# *Plan Alternativo for NAICM\**

## *Operational Viability Assessment*

**15 August 2018**

**MITRE**

# Plan Alternativo

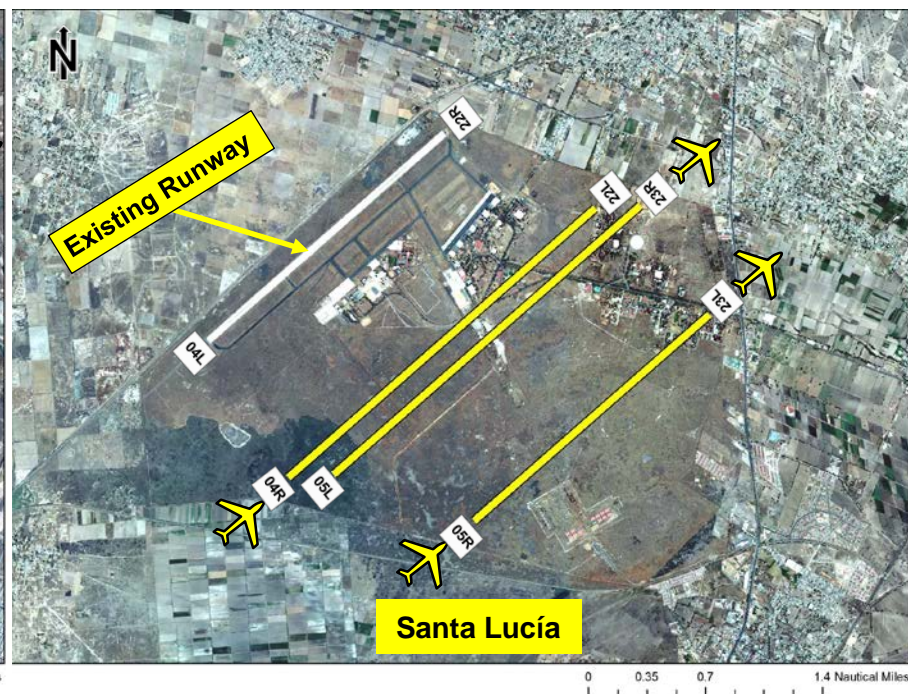
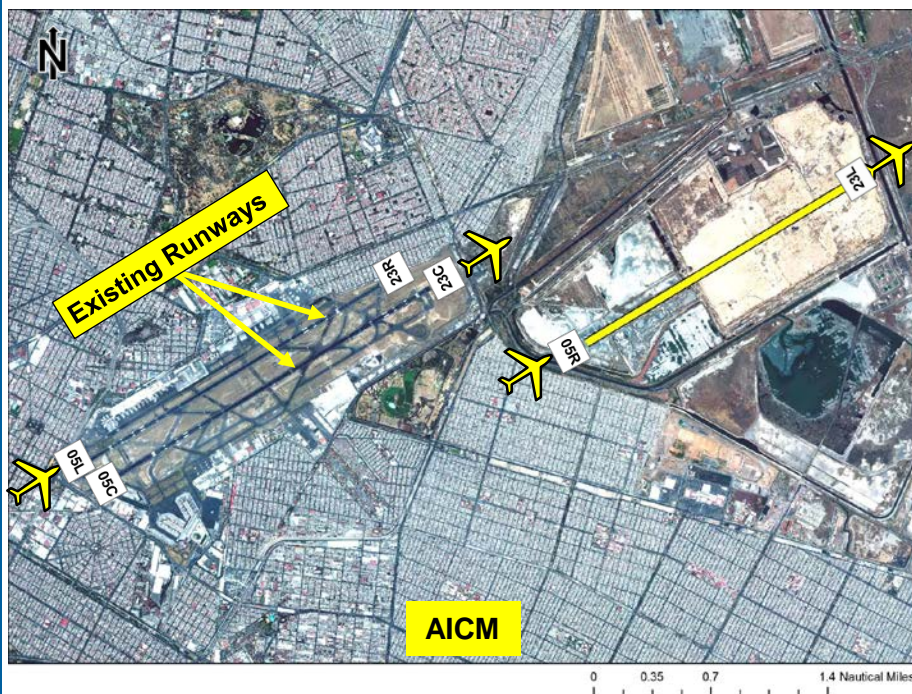
**As the 2015 Plan Alternativo did not show parallel runways, MITRE modified them (to ensure parallel runways) to simplify procedure design and air navigation.**

# Plan Alternativo

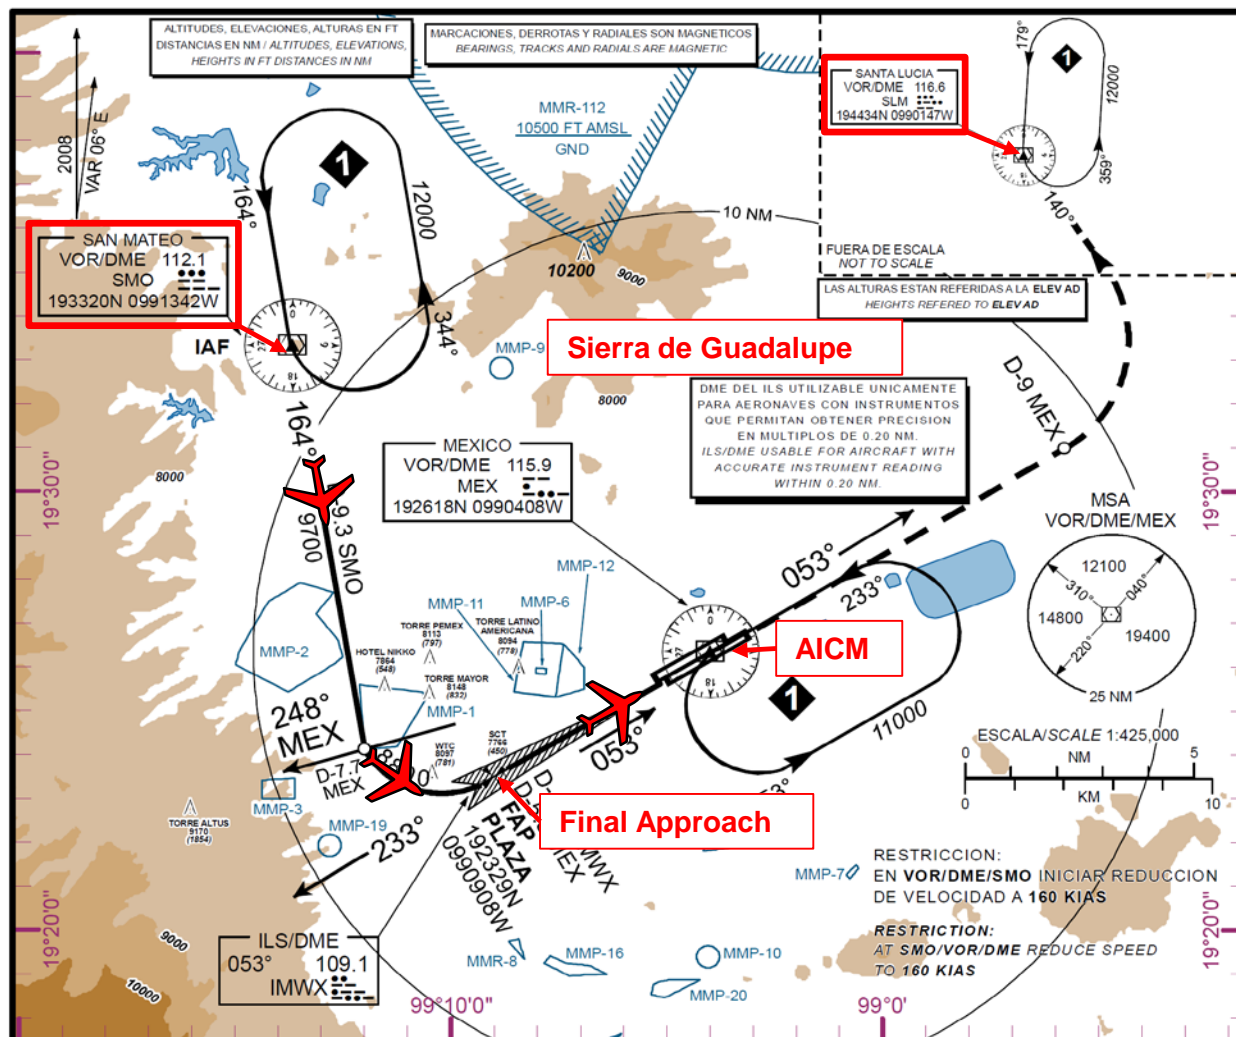
Notice an additional runway in the “Rellenos Sanitarios” area, located far from AICM’s terminals. As mentioned before, MITRE analyzed that area in the year 2000 and found it to be unfeasible.

Most runways are deemed by MITRE too short (approach lights, ~1.8 km, are also necessary) to achieve maximum payload and reach many long-range destinations. While less so, AICM is also limited. Thus, both Santa Lucía and AICM would remain limited.

# Radar Tracks Showing Typical Arrival Paths to AICM Today

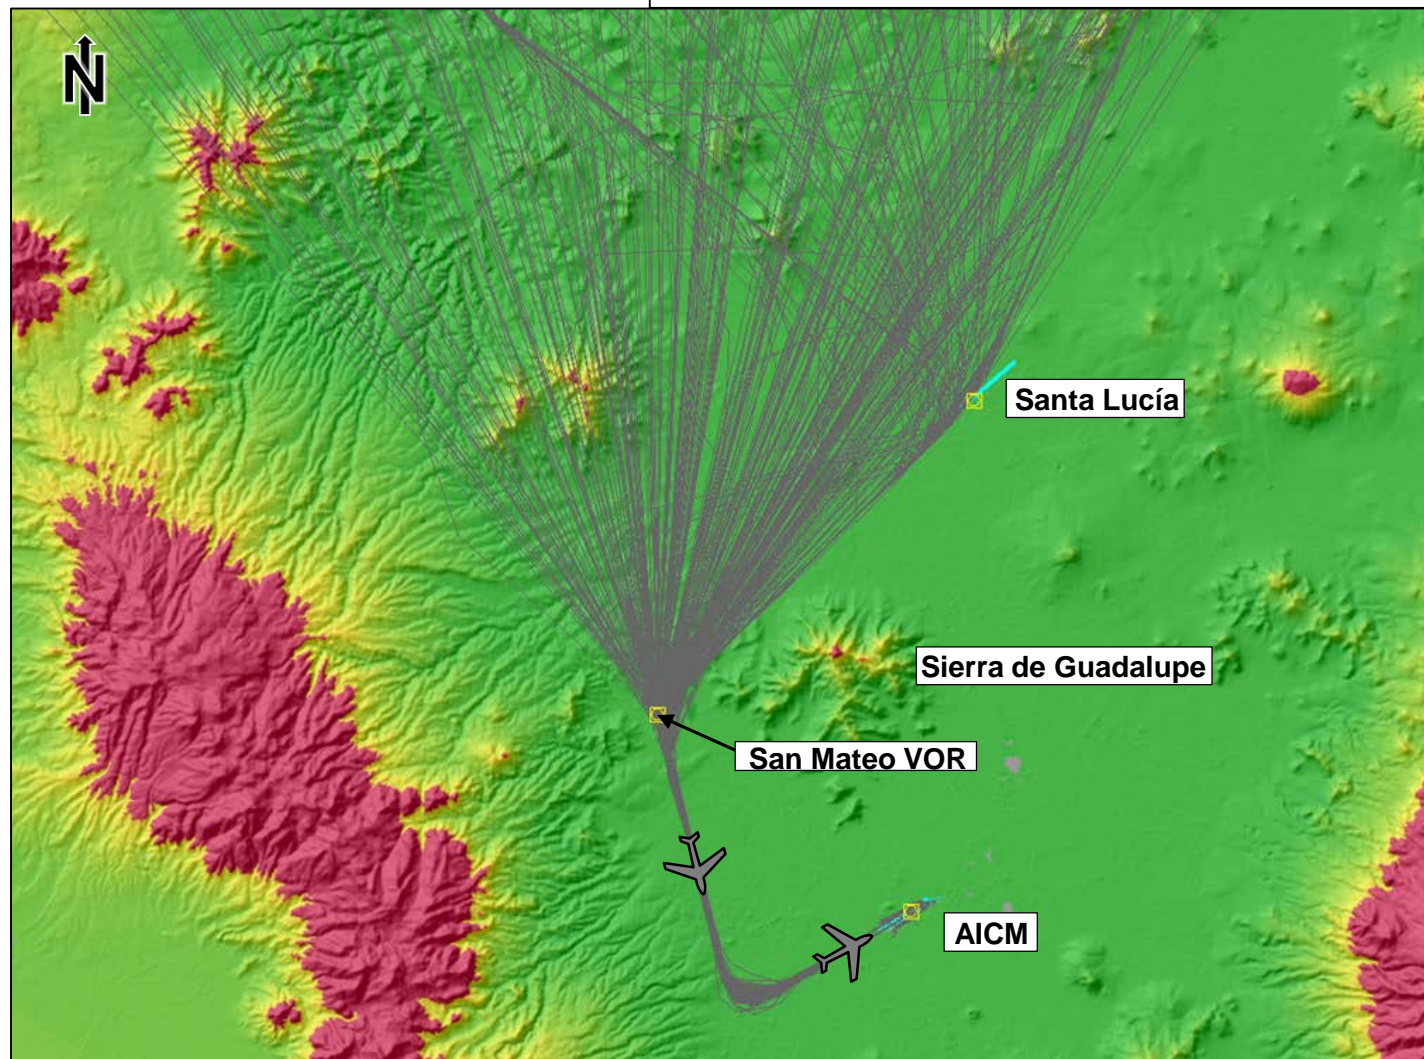
This large flight concentration, through the San Mateo VOR, is an unintended consequence of the traffic volume at AICM. NAICM procedures would eliminate such a concentration of traffic.

# Single Approach to AICM and (simultaneously) Single Approach to Santa Lucía

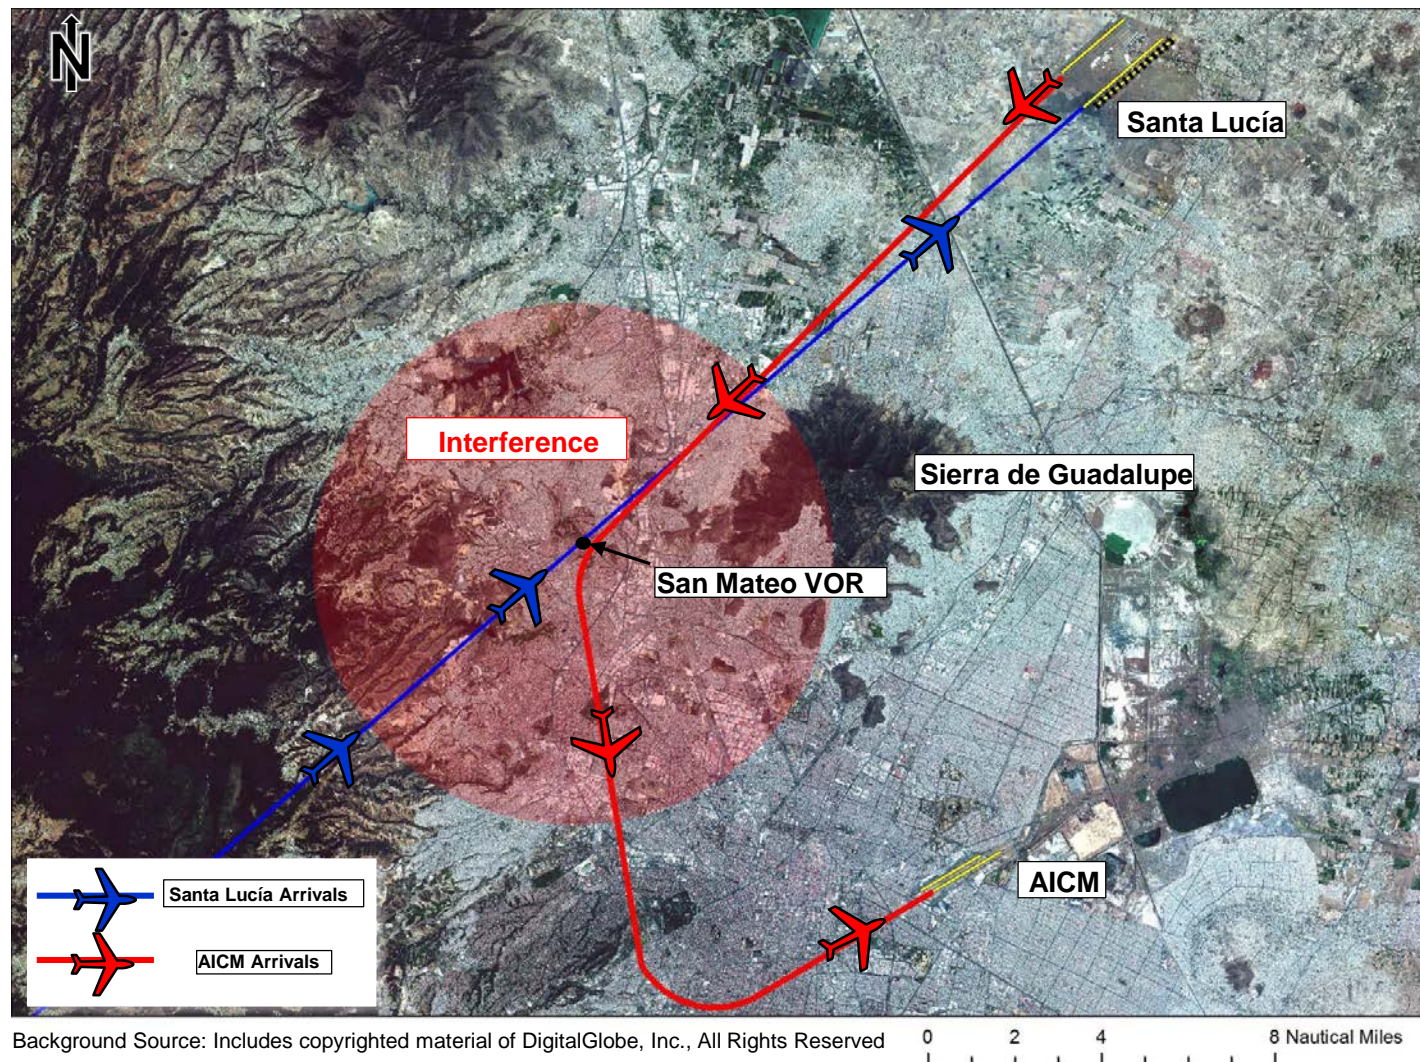
While the red line represents the combined published arrival/approach to AICM, many flights are routed directly to the San Mateo VOR (as shown in a previous slide), from many other directions, mostly through radar vectoring.

- **Single approach to each airport (conventional procedures)**
  - Creates an unacceptable area of interference at the San Mateo VOR
    - To ensure safety, long aircraft separations would be required and, as a result, global runway capacity in the area would not grow, leading to increasing delays, thus failing to resolve the enormous saturation levels at AICM

# Single Approach to AICM and (simultaneously) Dual Approaches to Santa Lucía

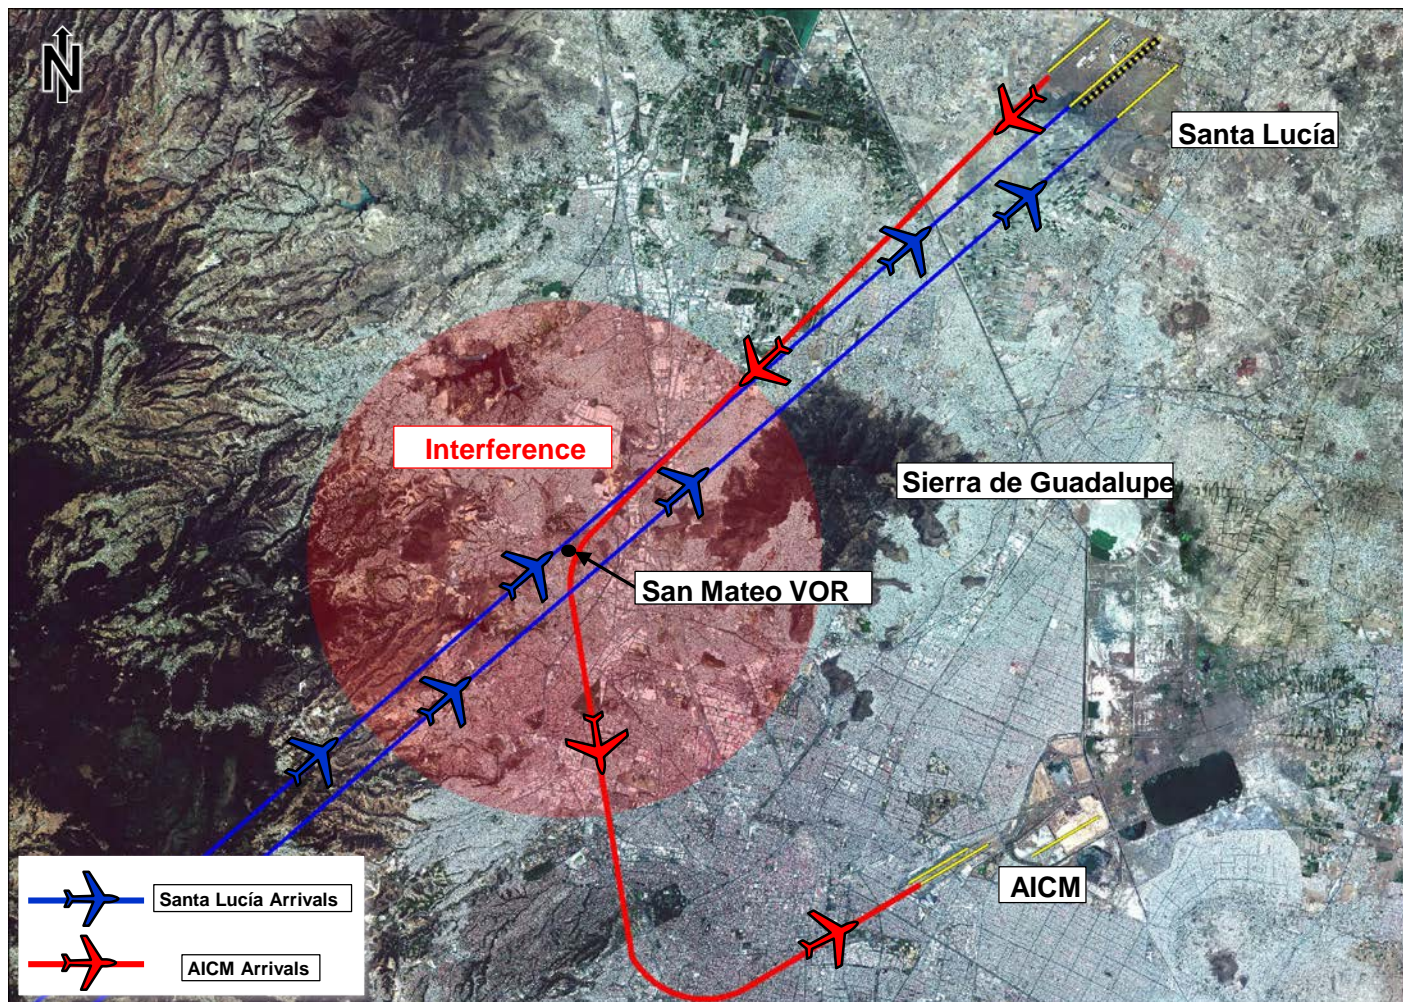
While the red line represents the combined published arrival/approach to AICM, many flights are routed directly to the San Mateo VOR (as shown in a previous slide), from many other directions, mostly through radar vectoring.

The blue lines represent what a two-runway simultaneous approach to Santa Lucía might look like, with one track very close to Sierra de Guadalupe.

- **A single approach to AICM and dual approaches to Santa Lucía (conventional procedures)**
  - Creates an unacceptable area of interference at the San Mateo VOR
    - Dual approaches only exacerbates the problem
  - Due to the proximity of Sierra de Guadalupe, approaches to Santa Lucía “on the right” would be very complex when dealing with breakout maneuvers, weather avoidance, and other non-standard flight conditions such as unstable approaches
    - Increased airspace traffic complexity at both airports would likely lead to additional delays
    - To ensure safety, longer aircraft separations (than those mentioned in the top bullet) would be required and runway capacity would not only not grow, but, paradoxically, airspace complexity may lead to larger delays

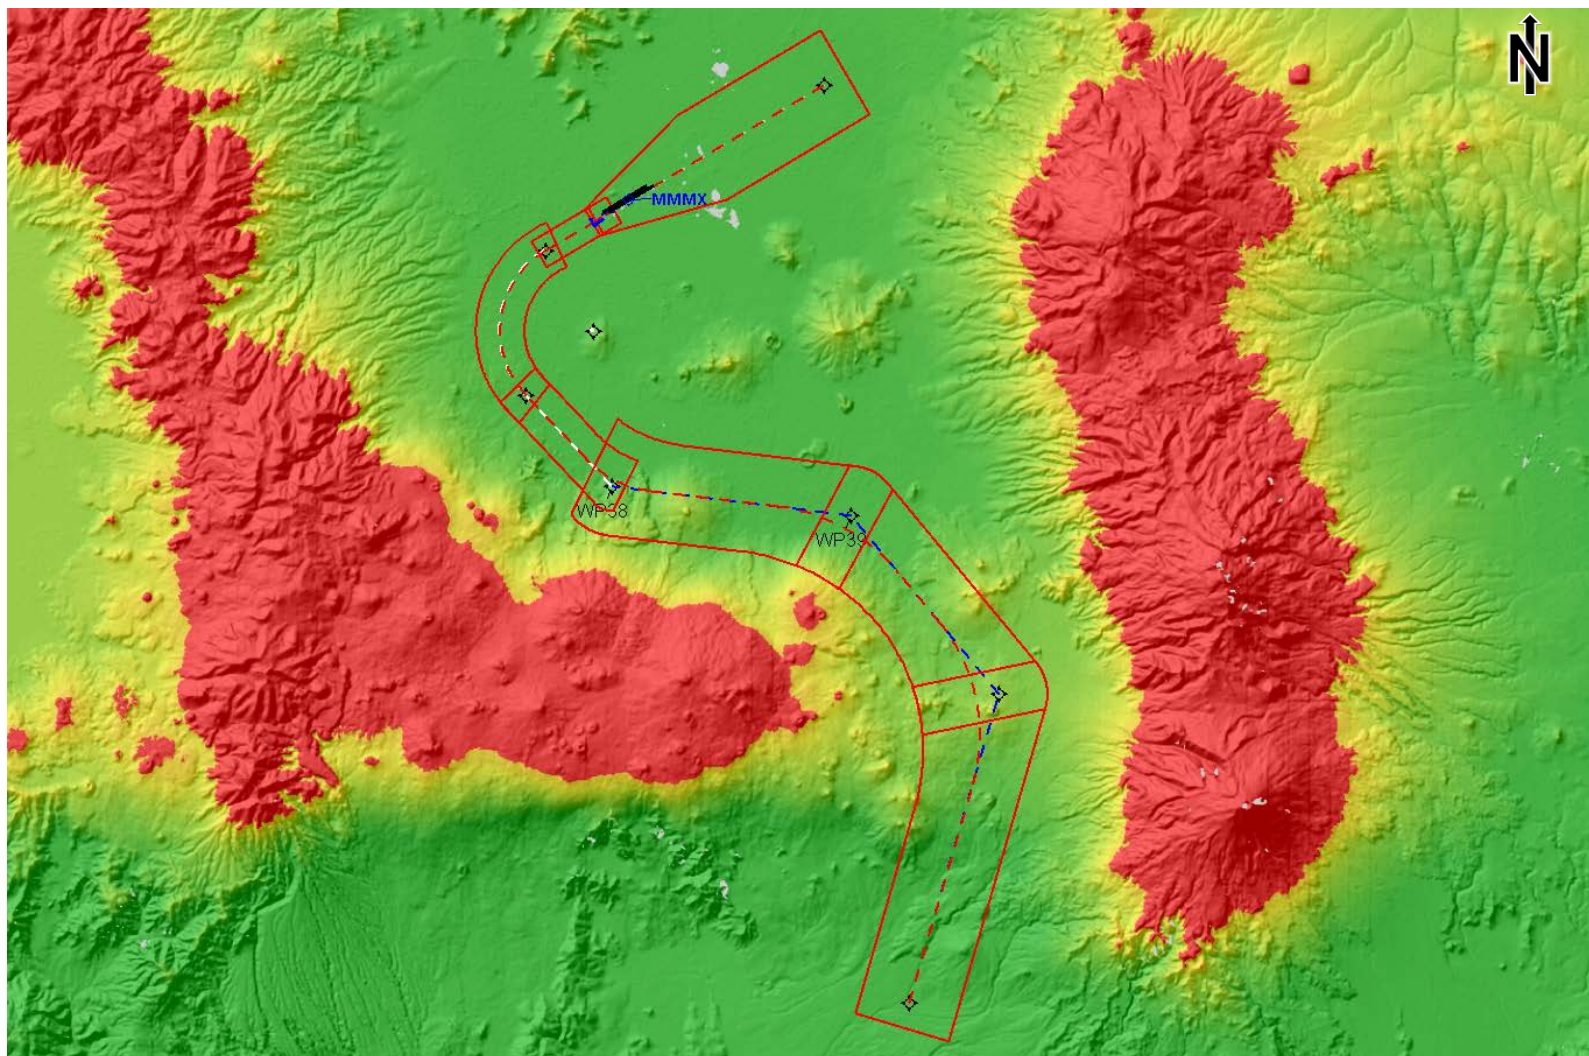
- Minimizes interference at the San Mateo VOR
  - Controllers would have no flexibility to sequence aircraft appropriately behind other aircraft landing on the same runway using this procedure

- Aircraft needing to discontinue their approach at certain points would have to climb to a new altitude that could conflict with AICM's traffic, causing disruptions at both airports

- Accurate integration of multiple procedures from different directions cannot be accurately achieved without radar vectoring or advanced controller tools that are not yet developed (see more on this later)

- Dual approaches to Santa Lucía under this procedure would exacerbate the above-mentioned issues; hence, a single approach to both airports would fail to resolve the saturation levels at AICM
